SUBJECT: TSTF Response to NRC Request for Additional Information on TSTF-592, Revision 0, "Revise Automatic Depressurization System (ADS) Instrumentation Requirements"

## **TSTF Response to NRC Questions on TSTF-592, Revision 0, "Revise Automatic Depressurization System (ADS) Instrumentation Requirements"**

**TSTF-592, Revision 1, "Revise Automatic Depressurization System  
(ADS) Instrumentation Requirements"**

REV 0 **Figure 3**  
 TITLE: ADS Channel "B" Logic

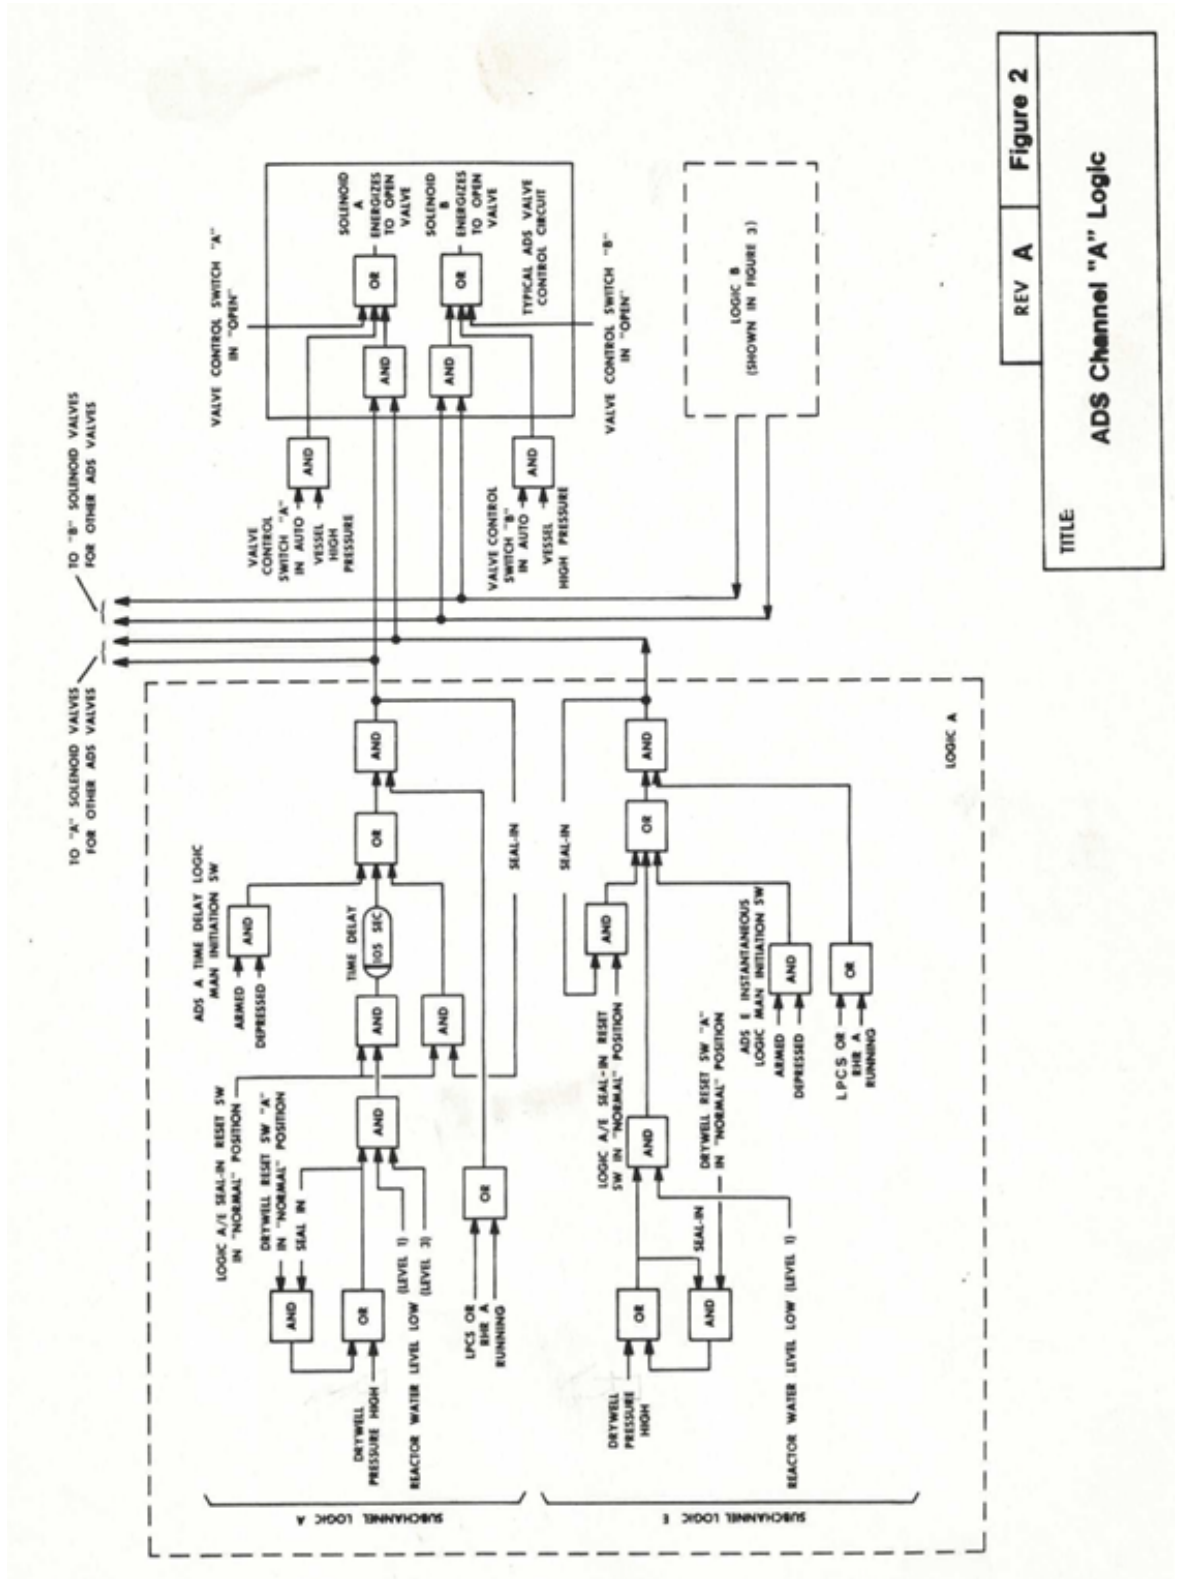
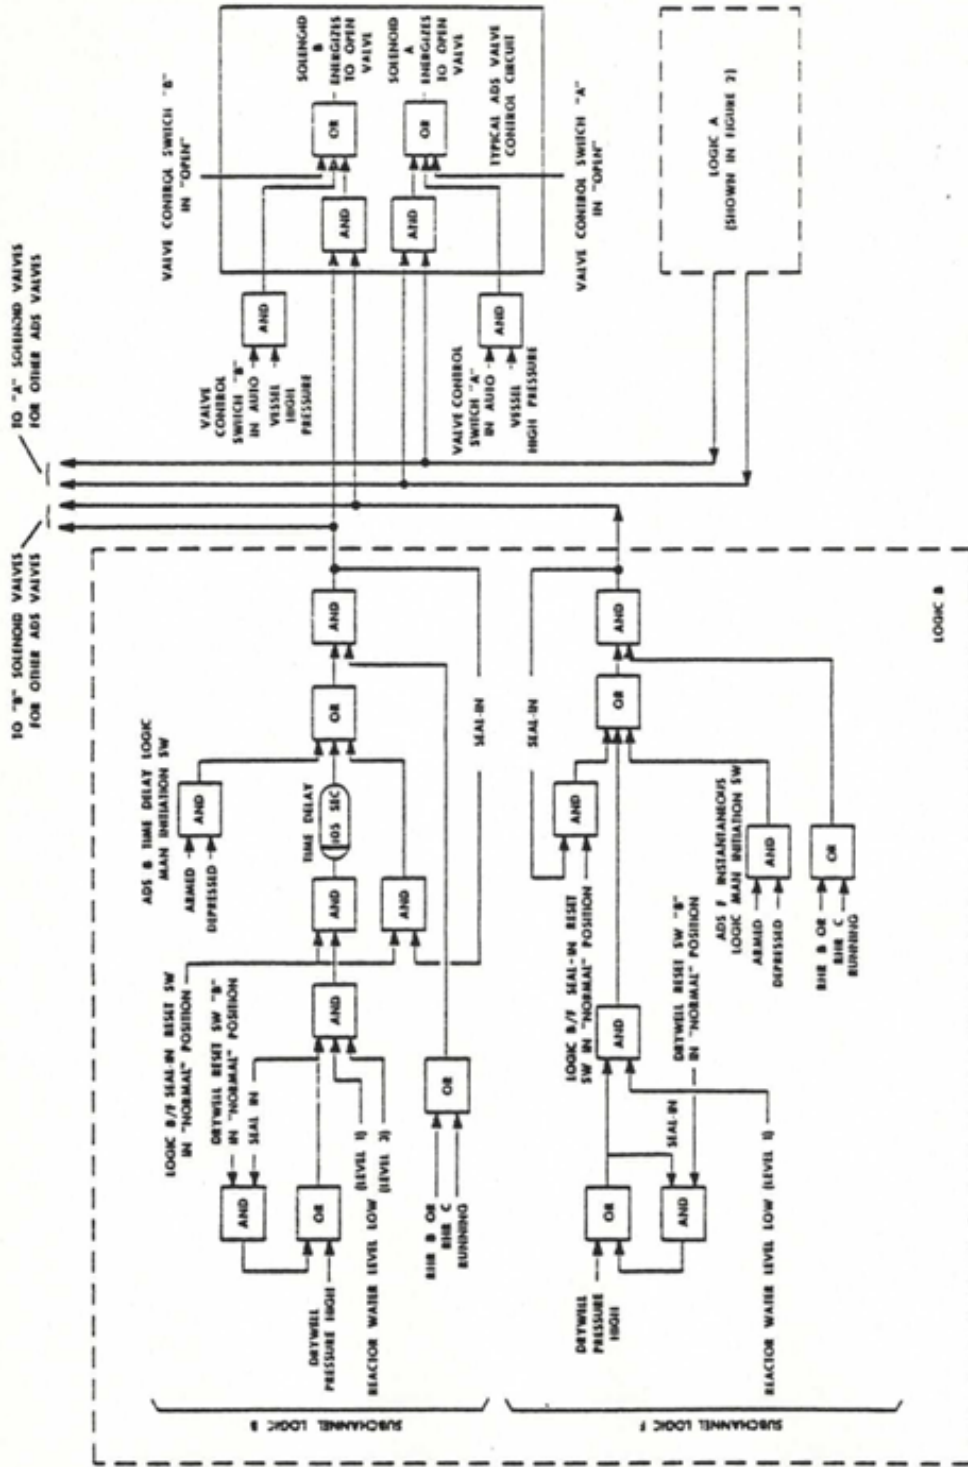
- 3. TSTF-592 did not provide logic diagrams for ADS Trip System A and ADS Trip System B. The NRC staff believes that diagrams would facilitate understanding of the ADS Trip System logic described in TSTF-592. Therefore, the NRC staff requests that TSTF-592 include simplified logic diagrams for the ADS Trip System. The diagrams should depict relays, contacts, and any other devices necessary to achieve ADS actuation, as well as any descriptive information to help interpret the diagrams.*

Generic ADS logic diagrams for the BWR/4 and BWR/6 designs are included as figures in the enclosed revised traveler along with a disclaimer that the figures do not necessarily represent every plant. It was determined that there are variations in the ADS logic across the BWR/4 fleet. Descriptions of two of these variations were added to traveler. These variations do not affect the applicability of the change. The model application was revised to include an optional variation for licensees to describe the plant's ADS logic if it differs from the design described in the STS Bases.
